JMT Consulting has been commissioned by the University of New South Wales (UNSW) to prepare this document in response to the issues raised in by government agencies, community organisation groups and the public during the public exhibition of the proposed UNSW Health Translation Hub (HTH) State Significant Development (**SSD**) application (SSD-10822510).

This document has been prepared to respond to the transport related issues raised by Transport for NSW and Randwick City Council as reproduced on the following pages.

Concept design road safety audit

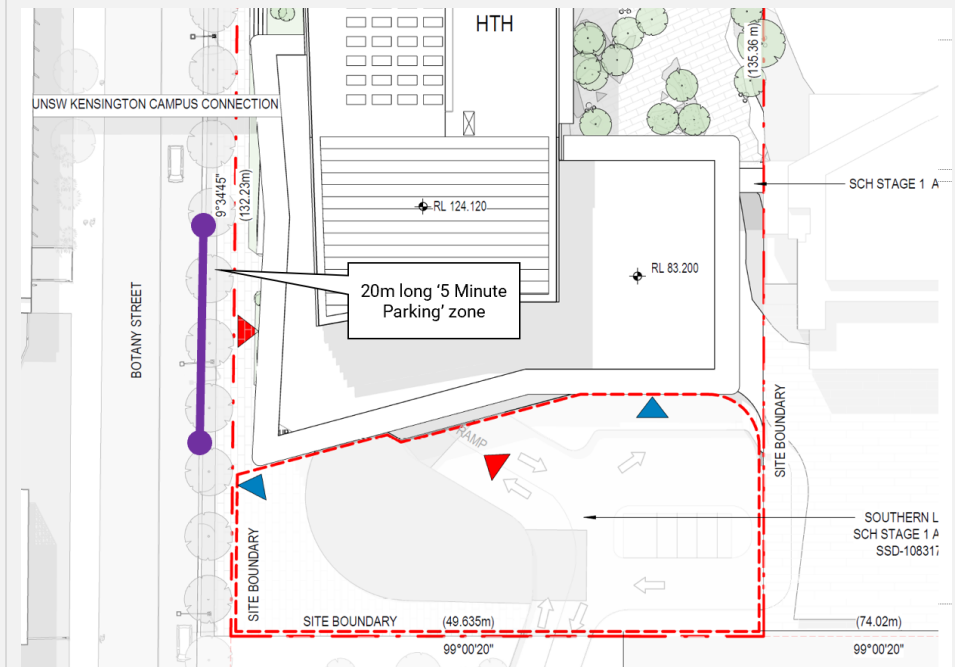
<p>The creation of an intended parking bay for the 'Pick Up/Drop Off' (PUDO) task along Botany Street is not supported. Along a 55m length of 1 hour parking, the creation of a PUDO bay affords no benefit. Indeed, the creation of the proposed PUDO actually reduces parking efficiency due to the required angled transition from the existing kerb line to the recessed kerb line. Council recommends</p>	<p>The Botany Street design has been modified to incorporate Council's suggestion of a continuous kerblane and removing the indented parking bay. A 20m long pick up and drop off area to be used by people accessing the UNSW HTH building will be provided along the Botany Street kerb, with this area to be</p>

Notwithstanding the above comments, it is recommended that the pathways in the vicinity of the proposed PUDO bay be constructed (and made available for the passage of the public). This will future-proof the option of subsequently

simply signposting the PUDO area while maintaining the existing shared path and providing the opportunity to continue some low level Botany Street landscaping elements. This signposted area will accommodate the PUDO task and have the adjacent shared path maintained at full width. In addition, a 'signposting only' solution provides flexibility to increase (or decrease) the length of the PUDO zone in the future, depending on demand over time.

signposted as '5 Minute Parking' to allow for the efficient drop off and pick up of passengers.

The location of this 20m long '5 Minute Parking' zone in the context of the continuous kerbline treatment is indicated in the figure below.

All pathways in the vicinity of the pick up / drop off area will be constructed and made available for public use. This will allow for the introduction of an indented drop off / pick up bay at a later point in time if required, consistent with Council's recommendation.

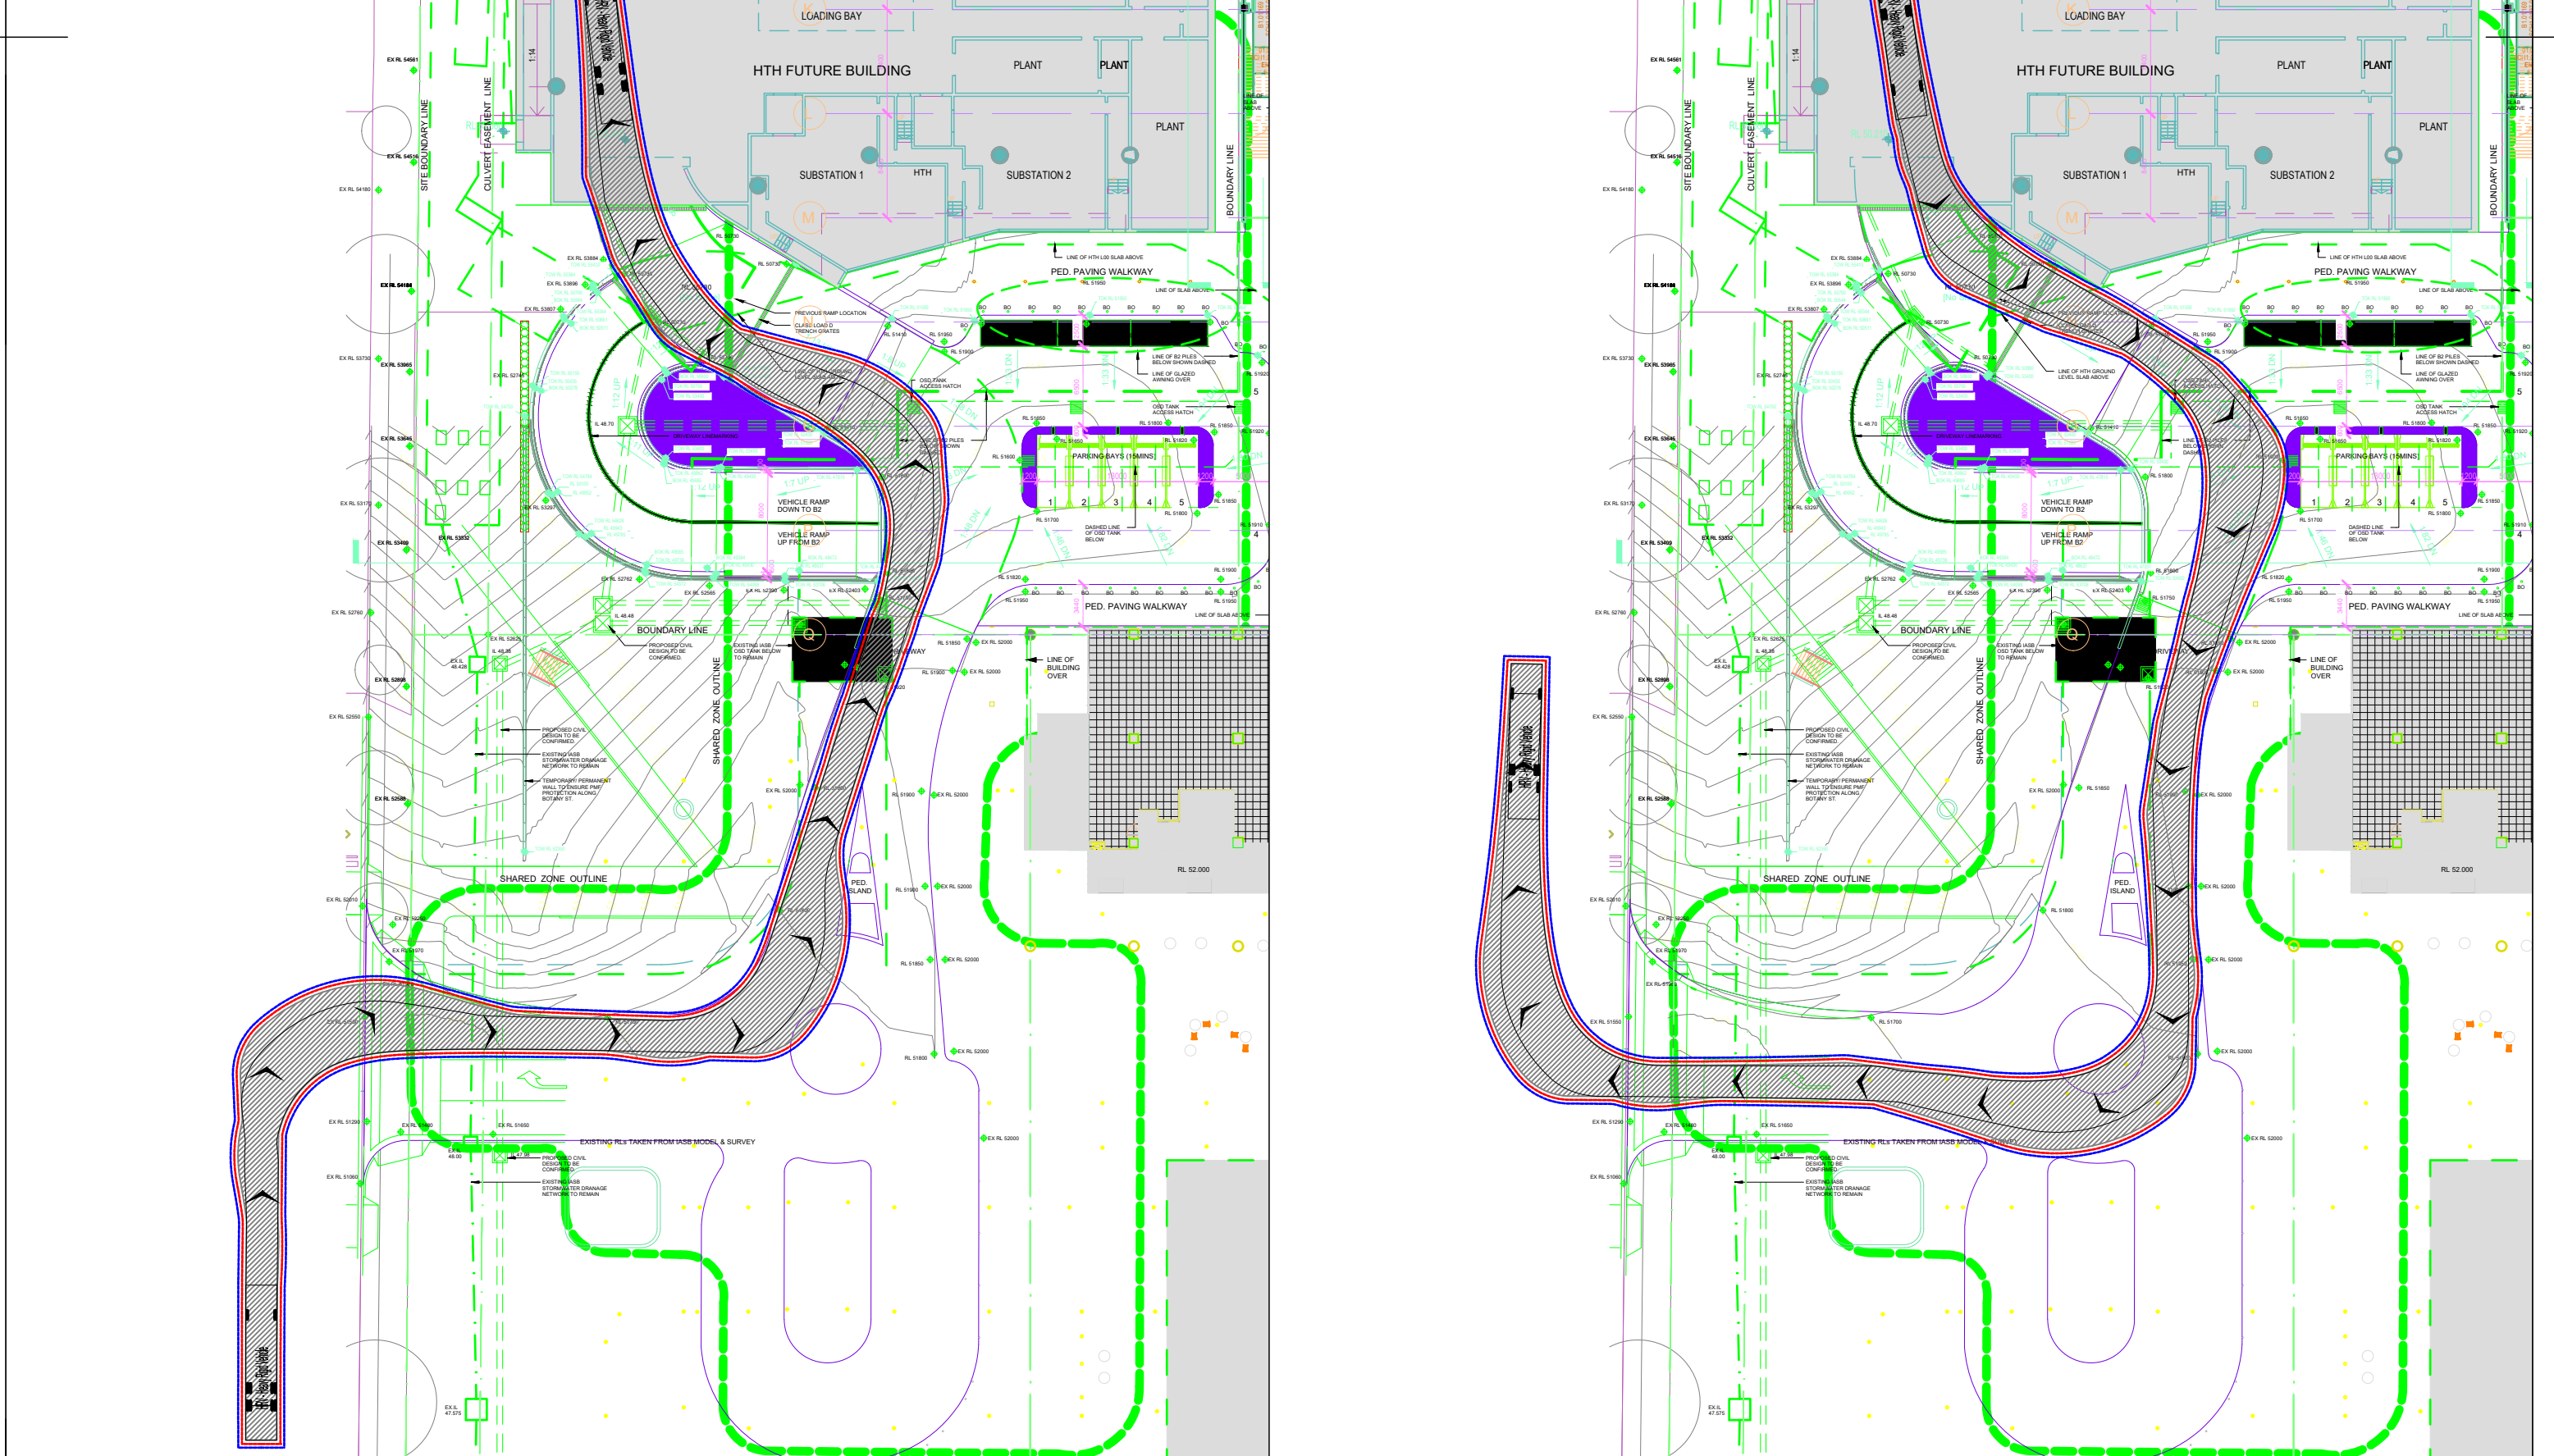
Transport for NSW Submission	JMT Consulting Response
<p><u>Comment</u></p> <p>Section 5.6 of the Transport Impact Assessment prepared to support the development application states the following:</p> <p>“It is proposed that approximately 20m of this 1 hour parking zone is redesignated as 5 minute parking (or similar) to facilitate pick up and drop off movements.”</p> <p>It is advised that kerbside restrictions are determined based on balancing needs of all users and are constantly subject to change and the proponent should not rely on the need for the suggested designated kerbside use.</p> <p><u>Recommendation</u></p> <p>It is requested that the applicant provides further detail on the point to point demand, how it would be managed, including the potential need for on-site provision to meet the demand as part of the Response to Submissions.</p>	<p>It is estimated that point to point demand may comprise of up to approximately 3% of total daily trips to the UNSW HTH building, of which half would occur within the dedicated drop off / pick up zone on Botany Street. This is equivalent to approximately 75 vehicle trips per day using the Botany Street drop off / pick up area, of which potentially 12-15 vehicle trips during the busiest hour of the day may be experienced. Assuming an average dwell time of three minutes per vehicle the drop off / pick up would have the capacity to handle 60 vehicles per hour – significantly exceeding the expected demands.</p> <p>The area would be managed through the introduction of appropriate signposting / kerbside restrictions to limit vehicle length of stay. '5 Minute Parking' is recommended to allow for the efficient drop off and pick up of passengers. The restrictions to be adopted will be confirmed following discussions with Randwick City Council closer to the opening of the site.</p> <p>On-site provision for drop off and pick up was considered however was not deemed suitable for the following reasons:</p> <ul style="list-style-type: none"> - The number of vehicle movements already expected to enter the forecourt area associated with the proposed Sydney Children's Hospital Stage 1 and Children's Comprehensive Cancer Centre building - The high number of different users already utilising the internal road system, including IASB drop off / pick up, SCH Stage 1 / CCCC emergency department drop off, SCH Stage 1 / CCCC general car parking, UNSW HTH building logistics access. - Objective of separating UNSW HTH logistics traffic with general drop off / pick up - Increased amount of space dedicated to pedestrians and landscape by minimising the amount of internal space required for traffic movements.

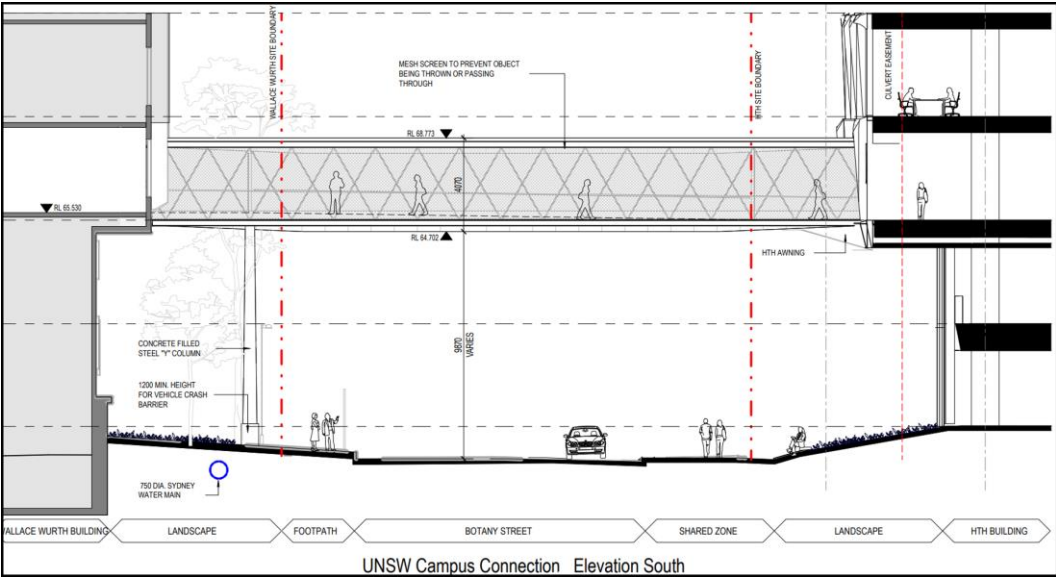
Although not shown on the architectural drawings, the Botany Street intersection with UNSW Gate 11 and the HTH vehicle access will be a four-way, traffic-signal-controlled intersection. This was confirmed by the project team and also expressly described in the Transport Report. The finer details of this signalised intersection (including both geometric design, as well as signal hardware and phasing design) were not available in the documents provided. However, relying on knowledge and experience with signalised intersections, the audit team were able to provide some high-level road safety issues. These issues should be considered in the refinement of the design and its progression to detailed design. The documentation of these issues in this report, does not forego the need to have the more detailed design formally reviewed and checked, when those plans are available.

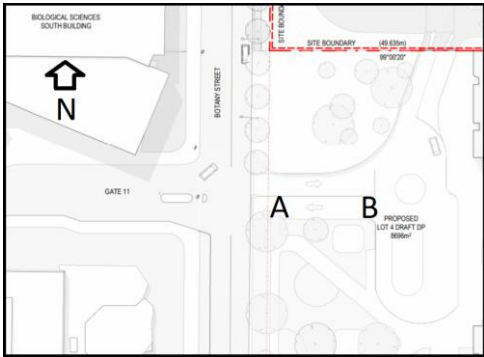
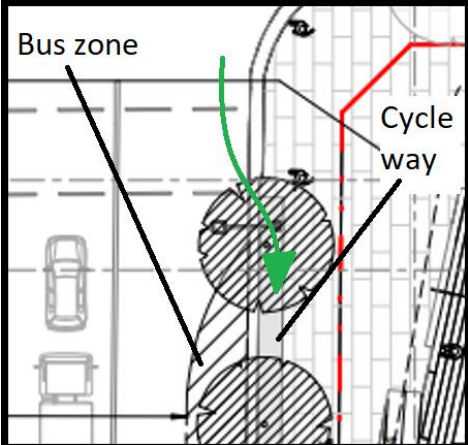
There were several discrepancies in the design documents regarding the intended status of the roadside area on the eastern side of Botany Street. Some design sheets referred to this area as a footpath, implying exclusive use by pedestrians except for cyclists under the special provisions of NSW Road Rule 250. Other design sheets referred to this as a shared path which allows combined use by pedestrians and cyclists. The audit team has considered that this will be a shared path. This is also consistent with the advice from the Transport Report.
